REGIONAL REVIEW NOTIFICATION

RE: Development of Regional Impact Review

Name of Proposal: Project Rita DRI 4094

<u>Description</u>: A DRI review of a proposal to construct 504,600 SF of data center space in two buildings on a 161-acre wooded site at the intersection of Kirkley Road and State Route 74 in Fayette County which is proposed for annexation by the Town of Tyrone.

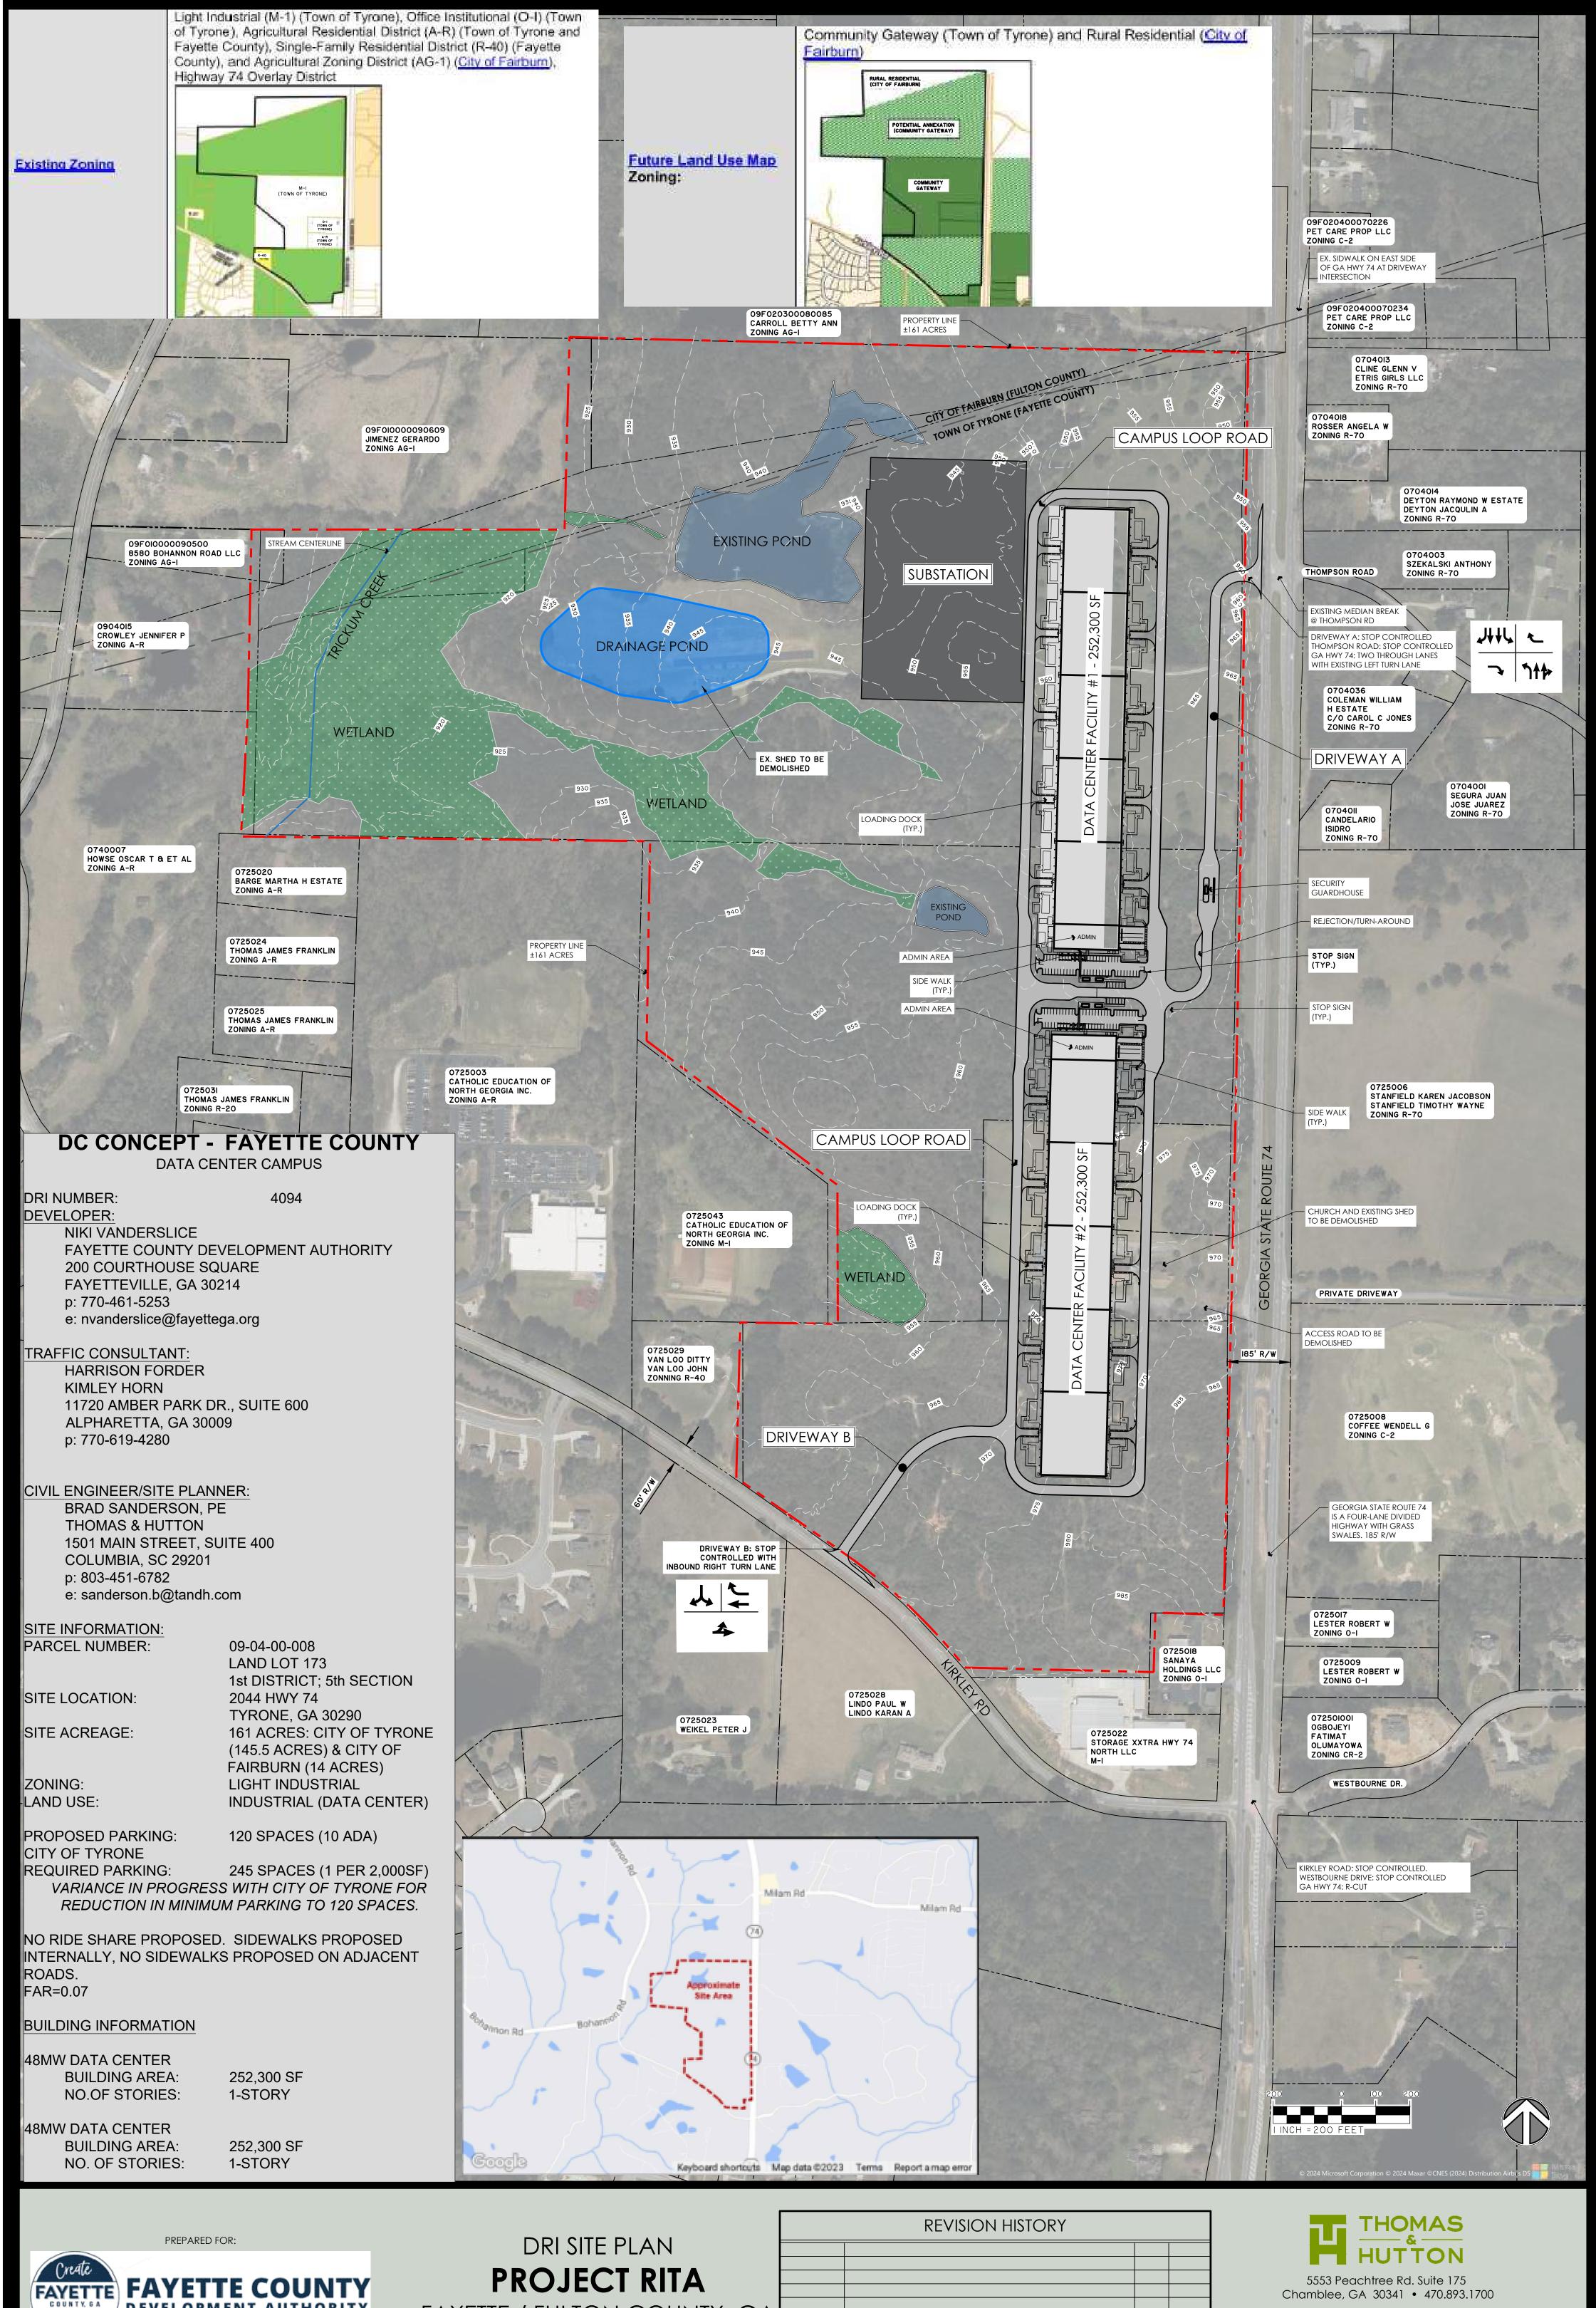
A variance has been requested to reduce parking spaces from 245 required to 120. A reduction in the number of required parking spaces would be supportive of regional transportation and environmental policies.

Care should be taken to ensure that the constructed development provides an interconnected, functional, clearly marked and comfortable pedestrian experience on all driveways, paths, entrances, and parking areas. To the maximum extent possible, new driveways and intersection corners where pedestrians will cross should be constructed with minimal curb radii to reduce speeds of turning vehicles and decrease crossing distances for pedestrians.

Utilization of green infrastructure and low-impact design techniques for project impervious areas, including additional trees and the use of flush rather than raised curb planting islands in parking areas, would be supportive of regional stormwater and environmental policies. A natural habitat focused design for the proposed drainage pond would also be supportive of regional environmental policies.

The project is commendably retaining a large amount of natural area which could potentially be incorporated into a management and preservation system of some kind to ensure its proper maintenance. The property owners may be able to benefit from some conservation incentives in this regard.
